NJPR-12-0043

**Missing Seismic Walkdown Checklist (SWC)**

Equipment ID No. T4100B009 Equip. Class<sup>1</sup> 11, Chillers

Equipment Description CCHVAC North Div 1 Air Conditioner Chiller

(DSCN0558)

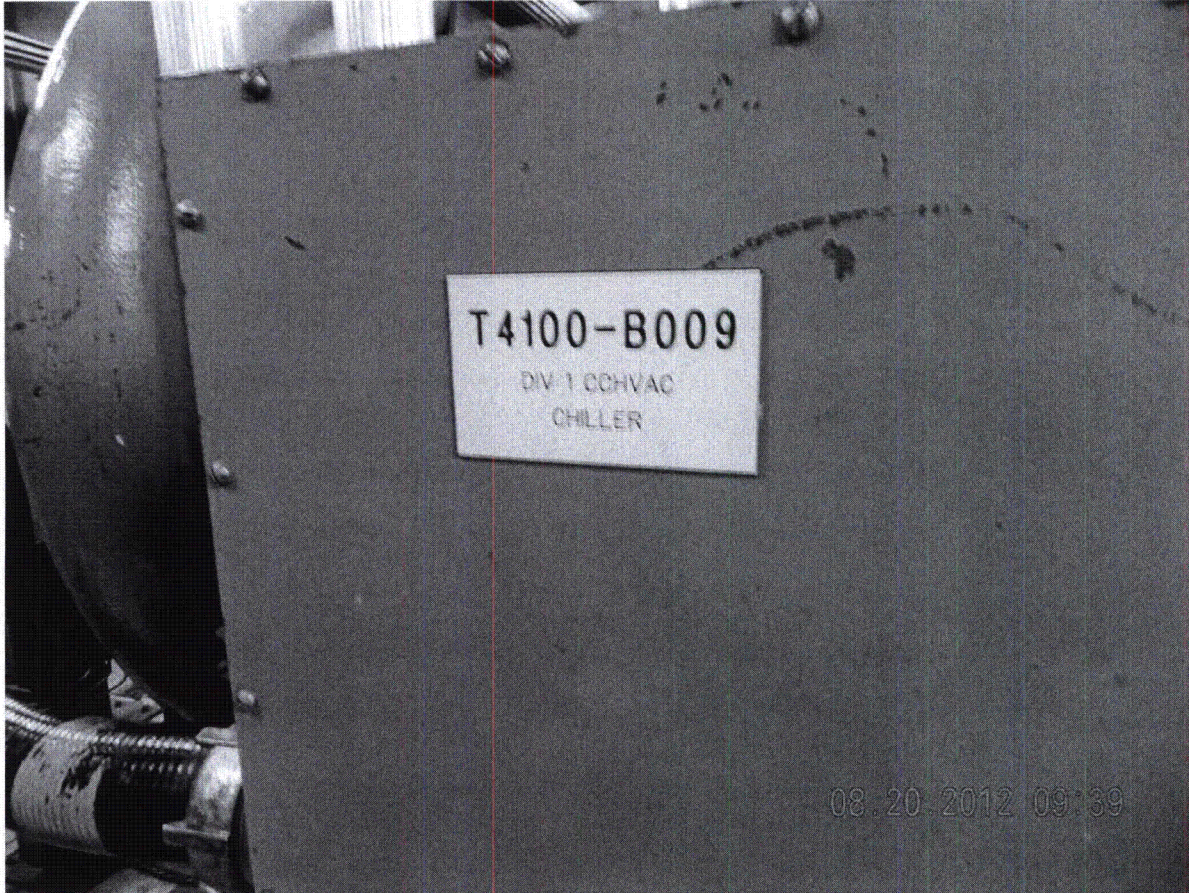
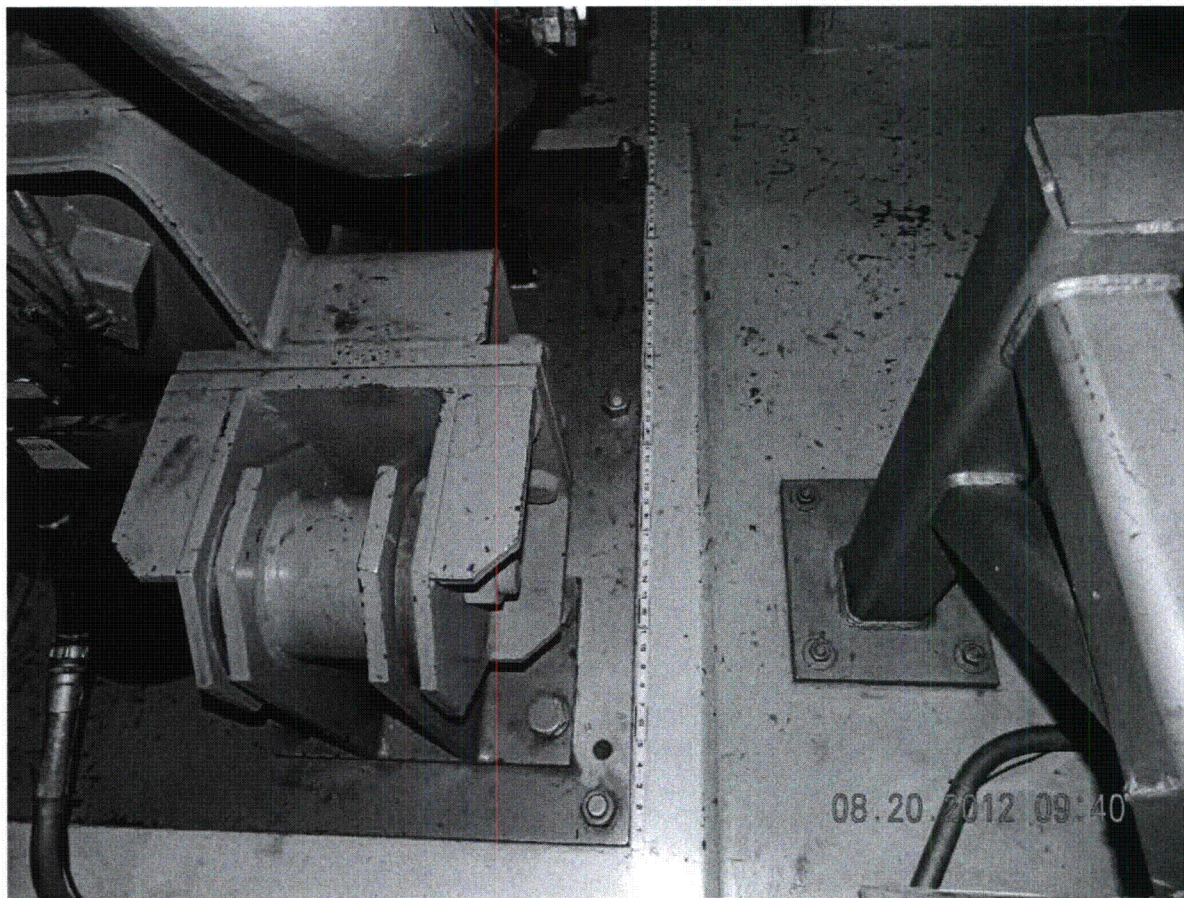
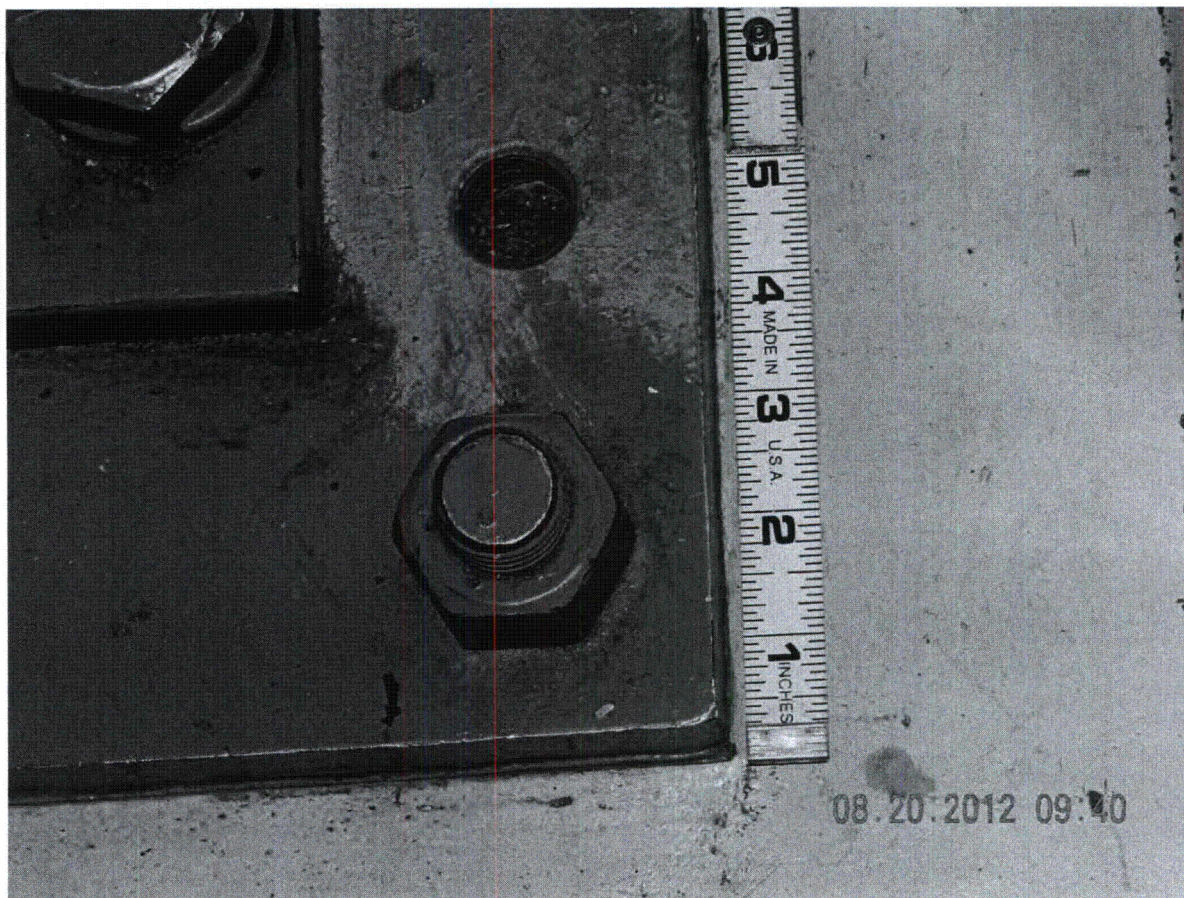
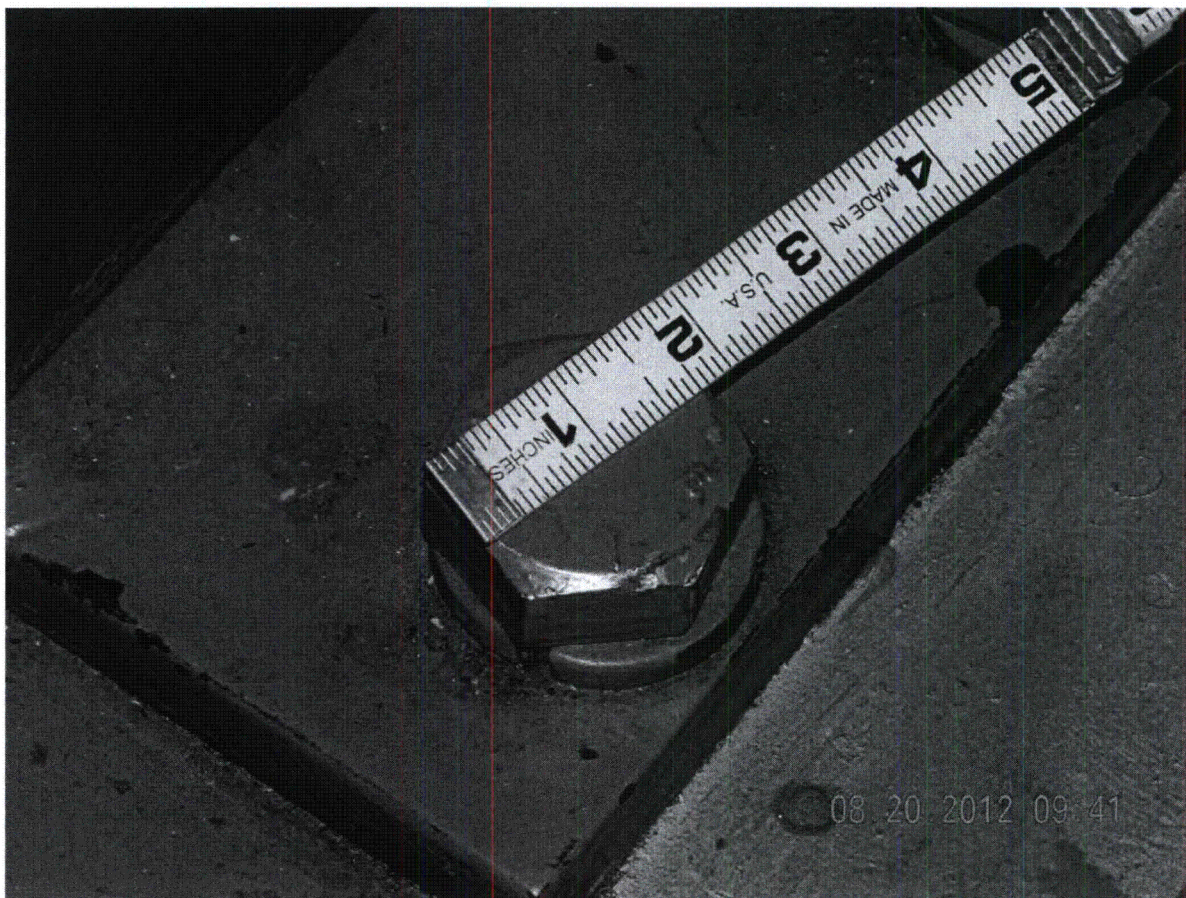
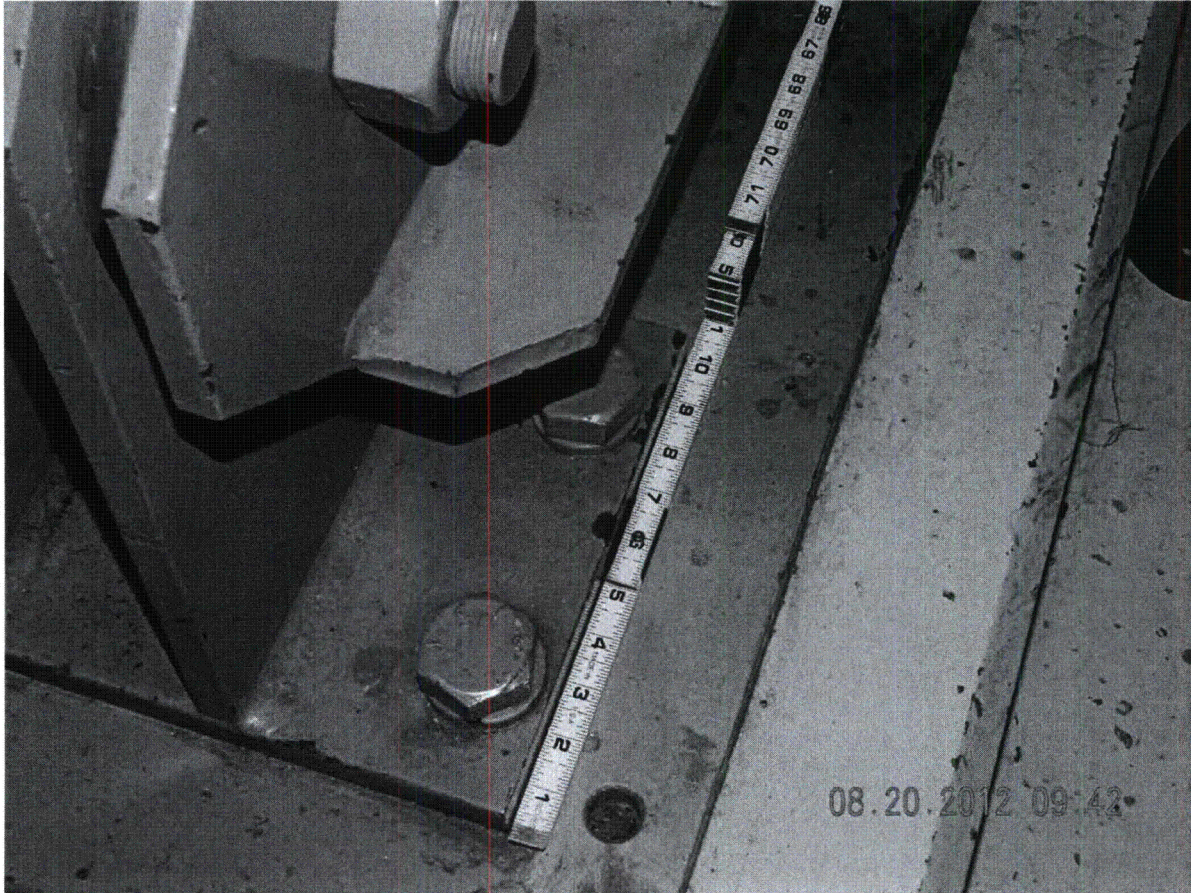
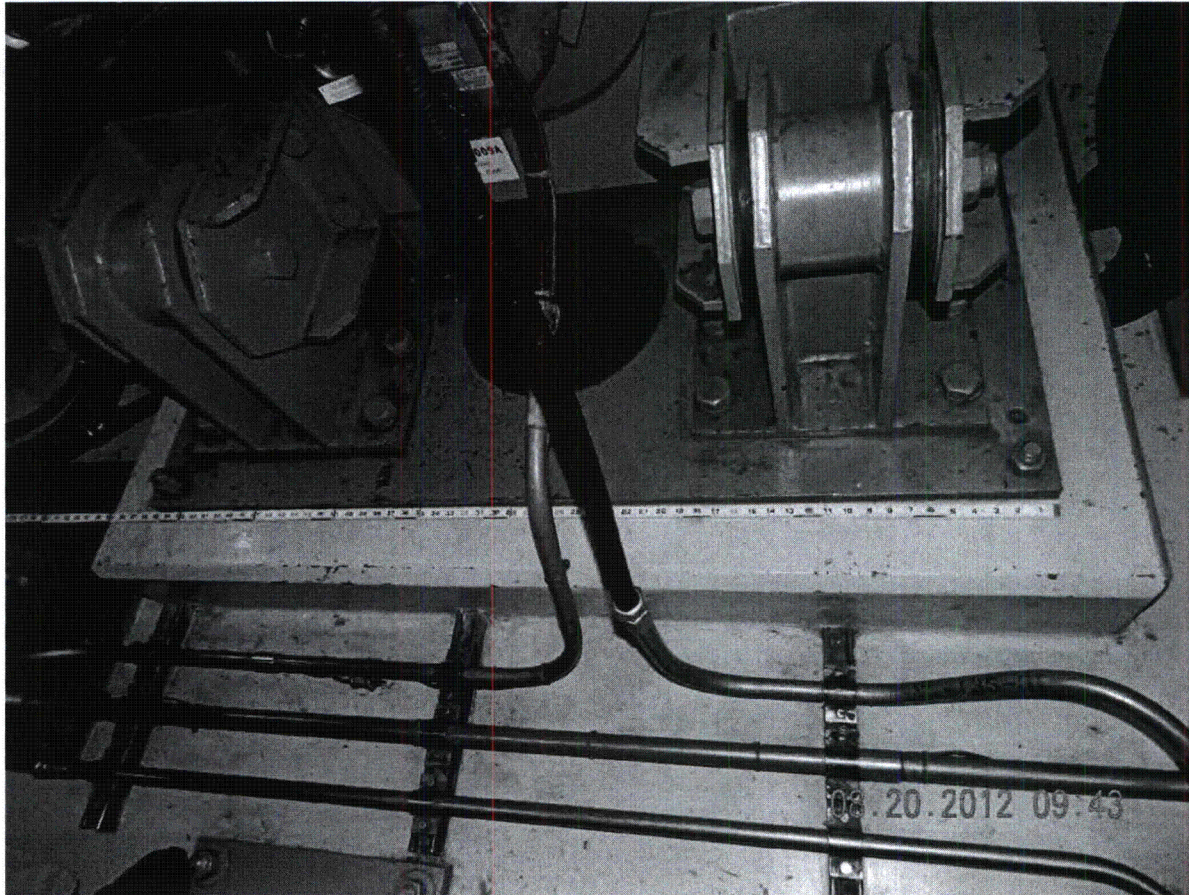
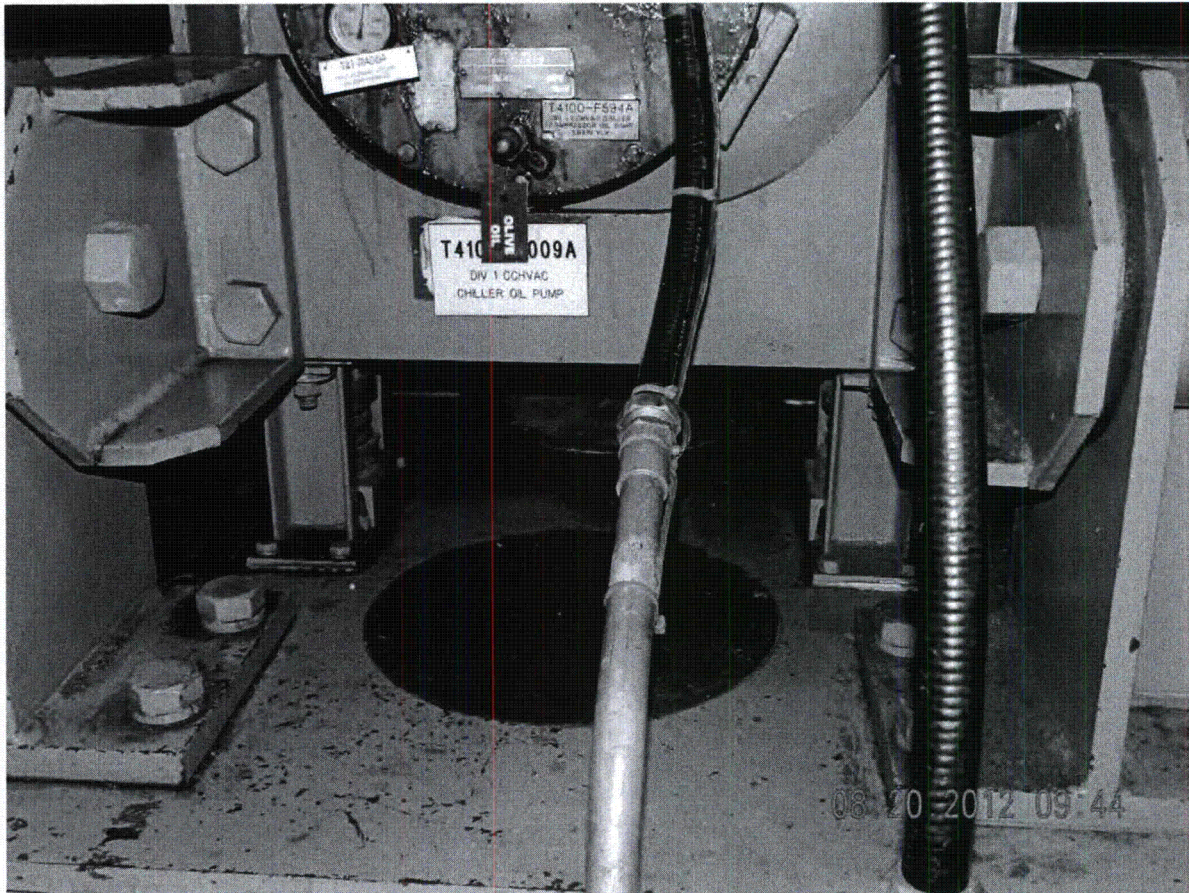
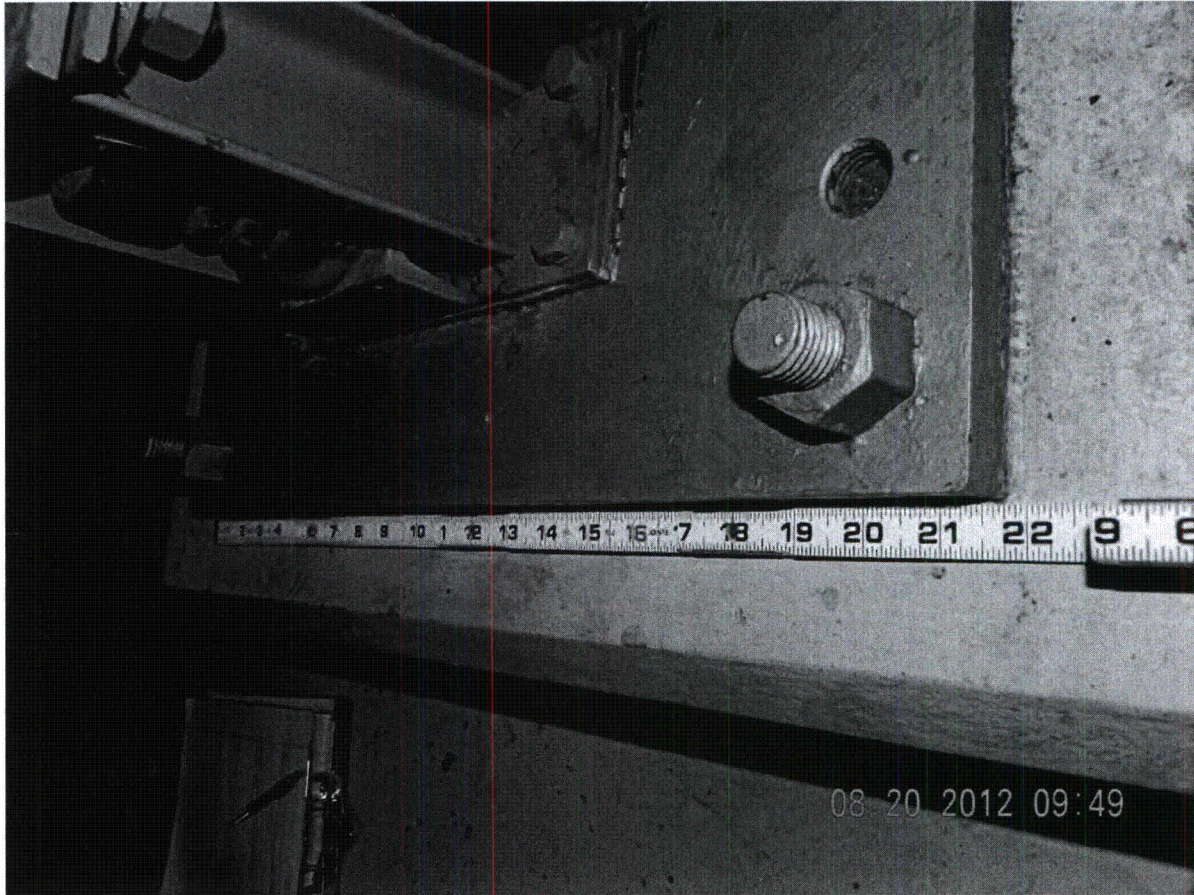
2. Is the anchorage free of bent, broken, missing or loose hardware?  Y  N  U  N/A  
*All bolts installed properly. Missing spring isolator bolt at SE spring isolator; See CARD 12-28245 for action. See photos DSCN0558-0569 and DSCN0576-0579.*

5. Is the anchorage configuration consistent with plant documentation?(Note: This question only applies if the item is one of the 50% for which an anchorage configuration verification is required.)  Y  N  U  N/A  
*Anchorage is consistent with drawing M-4007. Missing spring isolator bolt at SE spring isolator (See question No. 2)*

6. Based on the above anchorage evaluations, is the anchorage free of potentially adverse seismic conditions?  Y  N  U  
*The missing spring isolator bolt and questionable clearance at spring isolators are potentially adverse seismic conditions. Refer to CARDS 12-28245 and 12-28393 for resolution of the conditions.*
